STAFF REPORT
KETCHUM PLANNING AND ZONING COMMISSION
SPECIAL MEETING OF JUNE 22, 2020

PROJECT: 3020 Warm Springs Rd Duplex Design Review

FILE NUMBER: P20-031

APPLICATION TYPE: Design Review

LANDSCAPE PLAN

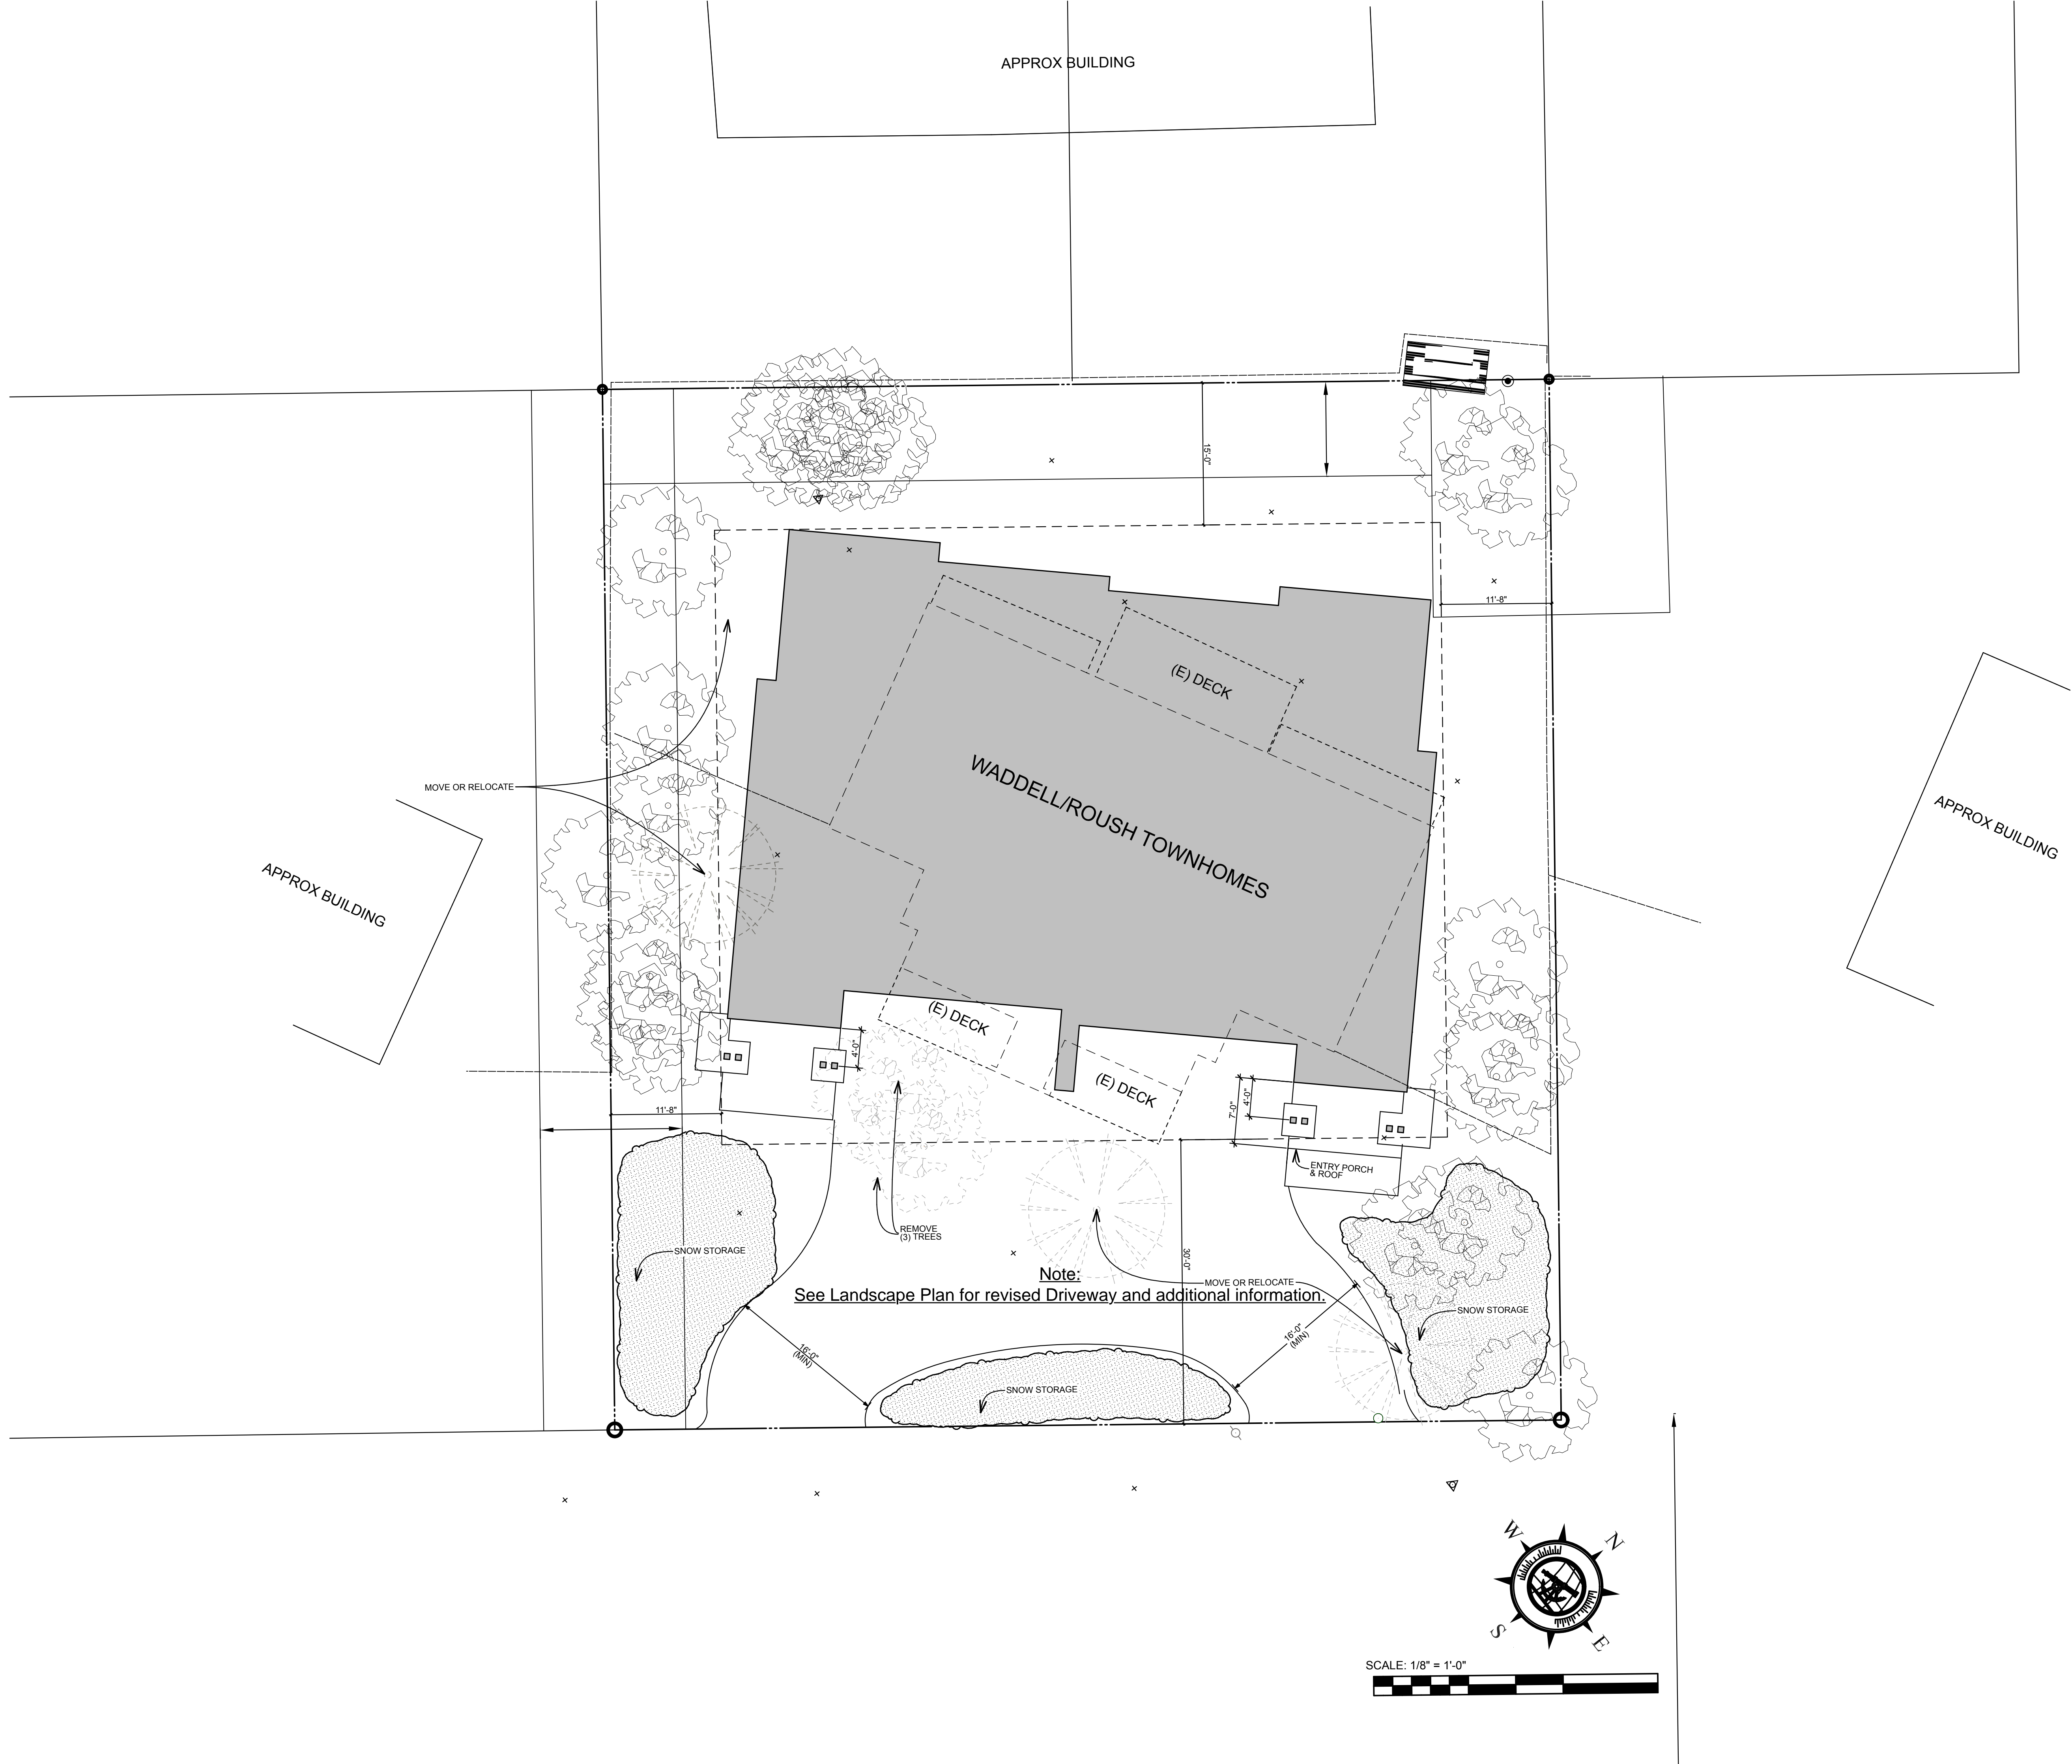
<i>Staff Comments</i>	<i>The updated landscape plan is indicated on Sheet L-01 of the project plans. Three new fir trees have been added to the backyard. These coniferous trees will help soften the rectangular building mass and provide visual relief at the rear elevation. Aspen trees have been added to the side yards. The island separating the two circular driveway entrances has been enhanced with new landscape plantings. The introduction of new trees and shrubs enhances screening between neighboring properties and Warm Springs Road.</i>
<input checked="" type="checkbox"/>	<input type="checkbox"/>	<input type="checkbox"/>	17.96.060.I2 Landscaping	Landscape materials and vegetation types specified shall be readily adaptable to a site's microclimate, soil conditions, orientation and aspect, and shall serve to enhance and complement the neighborhood and townscape.
			<i>Staff Comments</i>	<i>The landscape materials and vegetation types are indicated on Sheet L-01 of the project plans. See above analysis for KMC § 17.96.060.I1. All landscape materials and vegetation types shall be readily adaptable to the site's microclimate, soil conditions, orientation, and aspect.</i>

NORTH EXTERIOR ELEVATION

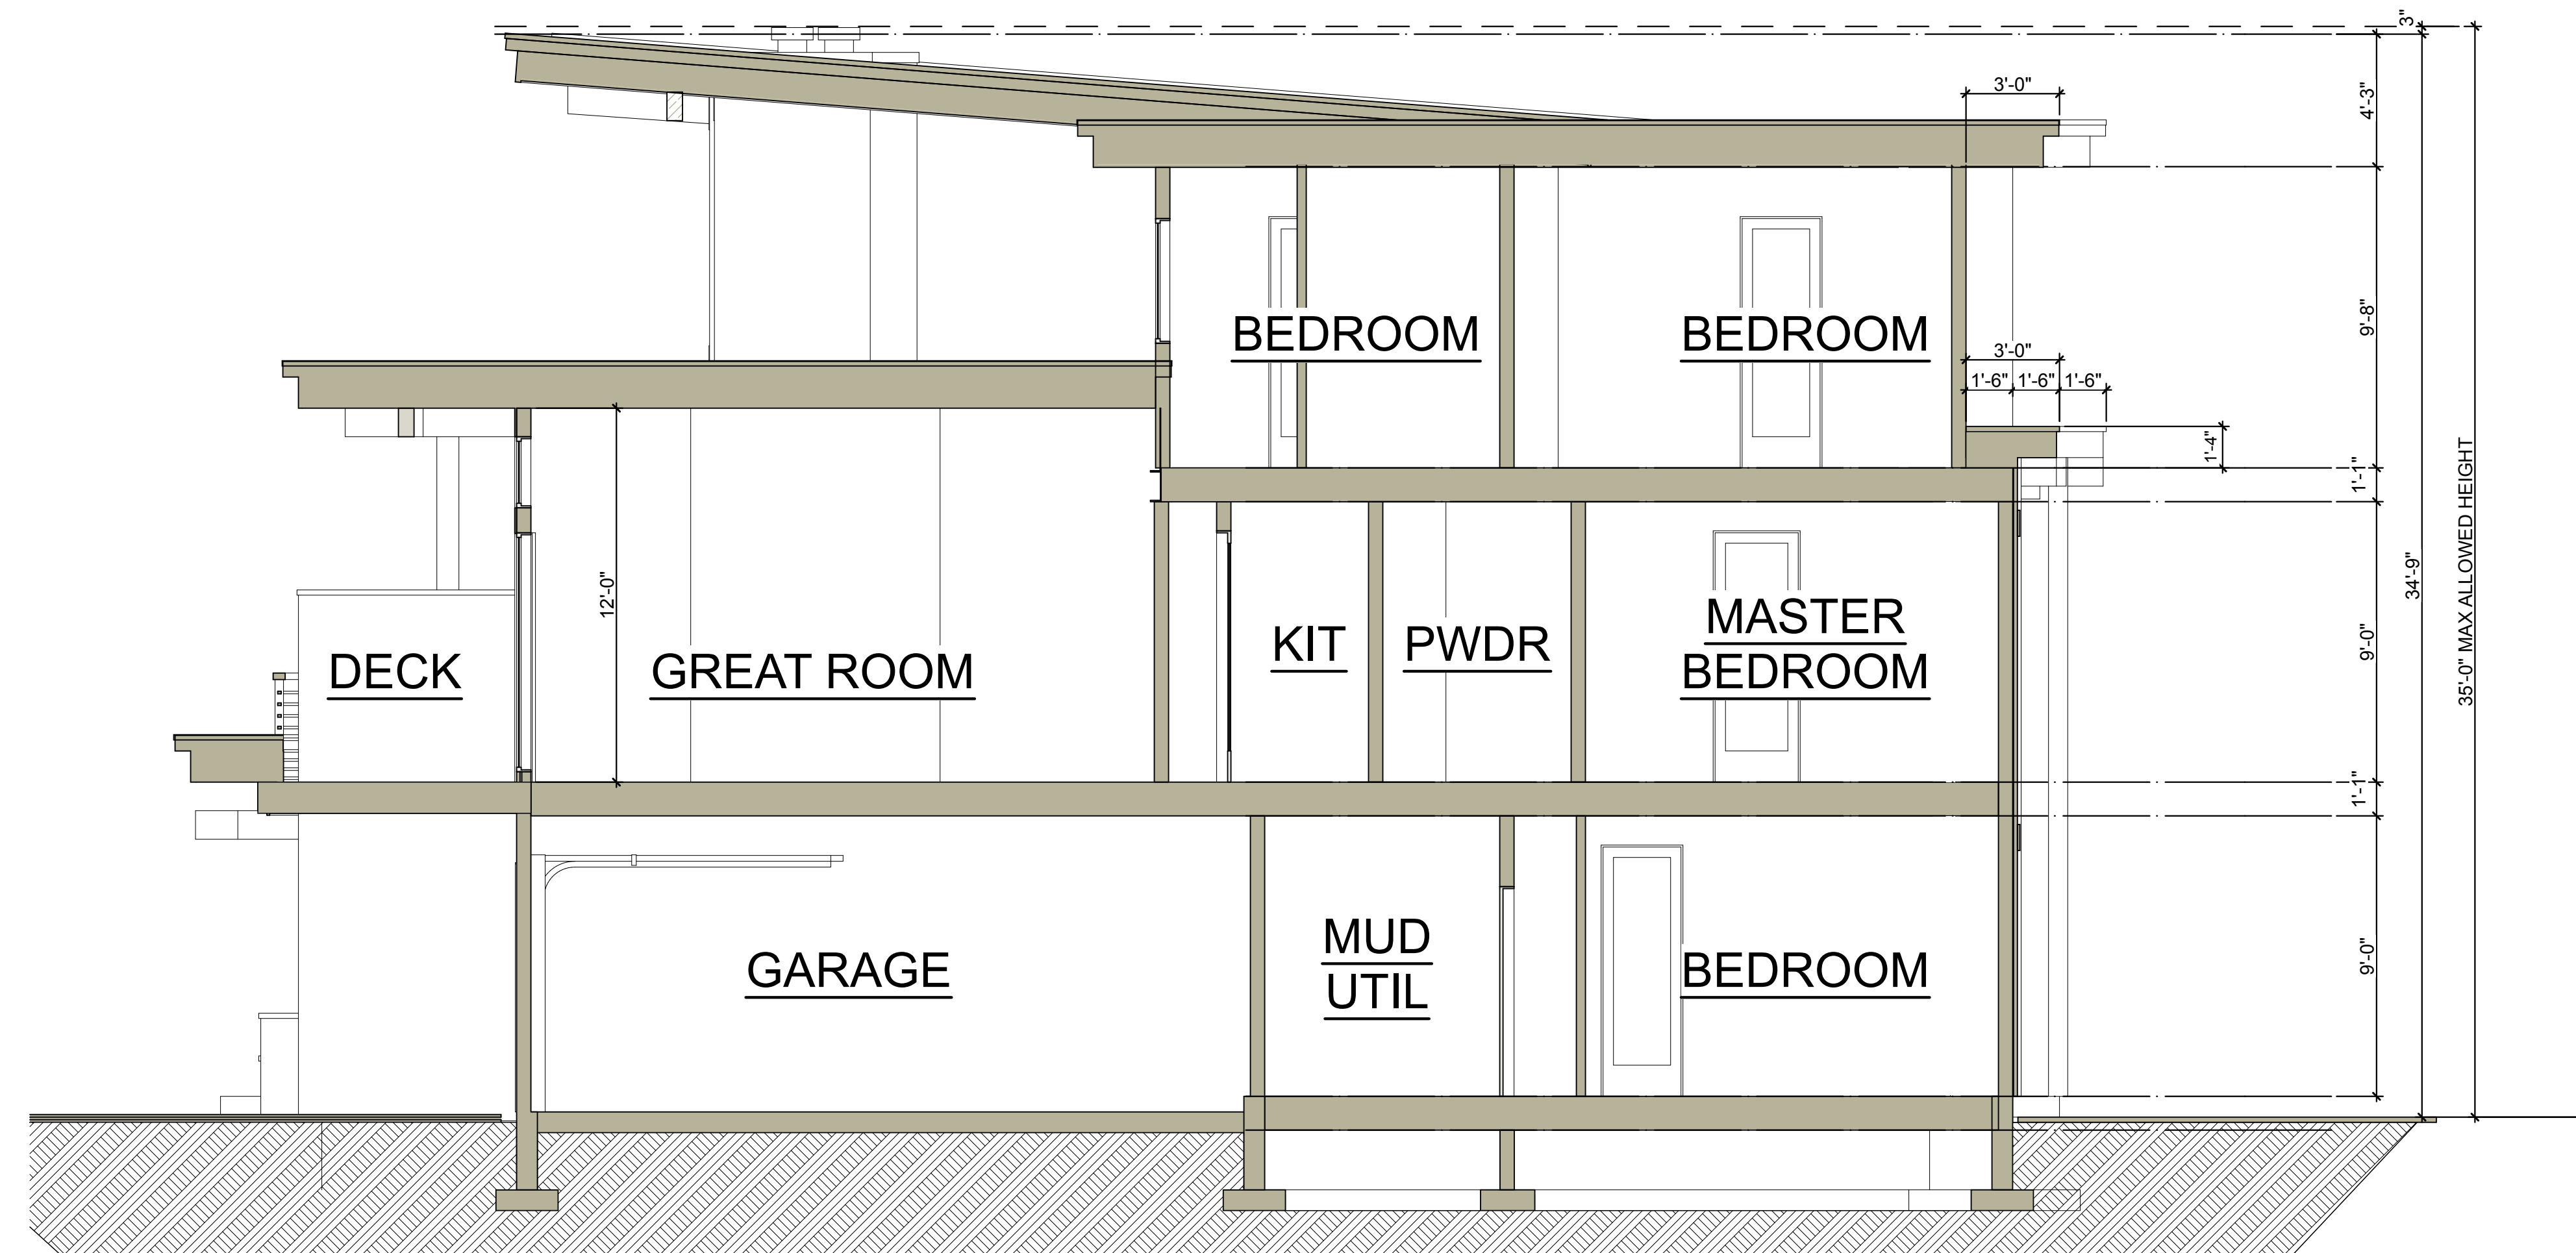
1. The biggest and most dramatic change is the Upper Level of the North/back wall of the Duplex has been moved in 18" from its previous location. The owners have agreed to the square footage reductions and the additional cost this change will require at the Upper Level:

- The Bedroom and Bathroom sizes have been reduced to facilitate this.
 - The wall below remains in the same place. The revised wall location and necessary additional roof at the Main Level create a strong datum that highlights the horizontal undulation of the rear façade.

- The Upper Level roof overhang is now back 18" from its previous position.
 - The cedar siding has been revised to accommodate the changes and make for a pleasing and varied Elevation.

- The Lower Level windows that the Commission was concerned about have been returned to the project.
 - The corners at the cedar siding portion of the façade have been highlighted with 2 X 12 trim. This increases interest, variety, and calls more attention to the existing vertical undulation in the facade.

- Cosmetic Headers were added to the windows in the cedar siding portion of these facades to add visual interest.
2. I continue to feel that the project has been well within the code requirements of the Design Review Evaluation Standards (17.96.060) of the Ketchum Code. We have made these aggressive changes in hopes of making a more pleasing façade, which will be screened by trees, but still visible to the neighbors to the North. I feel we are now well beyond what is required by the Ketchum Code.

- Unfortunately, the north elevation remains essentially a flat wall, and the side tier structural change on the third floor benefiting east and west neighbors is indistinguishable for adjacent north neighbors. In fairness to the Waddells and adjacent neighbors we ask the commission to request specific guidance. As requested in the prior two design review meetings, we again request the commission to specifically ask for structural design changes incorporating city code to all project elevations. Where it is nice the east and west 3rd floor tiers were enhanced, the primary orientation of side neighbors is north and south. It was well stated by a commissioner in the last design review, that Warm Springs homes are unique and orientations are north and south. 3020 WSR project has completely written off the north view, stripped of potential balcony or even a door that could tie them to the deer and elk, along with the four season landscape beauty in stark contrast to deep blue skies. Instead the proposed conifers show the intent of owners soften a monolithic wall, to eventually wall off the north. Conifers do as conifers do, grow tall and never lose needles...

§ There has been repeated commissioner comment and question on the degree of undulation and the degree of relief. There is a level of subjectivity, but degree is not the measure. Reducing the appearance of bulk and flatness is the measure. It is included in the code as structural compliance, not cosmetic. When a commissioner states in the same meeting, "I totally understand the concerns of the adjacent neighbors...It is a large wall in your back yard." It seems there is still work to be done on the remedy. Tiered (wedding caked) design elements as the building increased in floors best accomplishes reduction in appearance of bulk and flatness. Again, when reviewing this latest design the question is: Do the building walls reduce the appearance of bulk and flatness? From the north, slightly askew or not, this structure as revised and presented remains and expansive, massive, and monolithic flat wall.
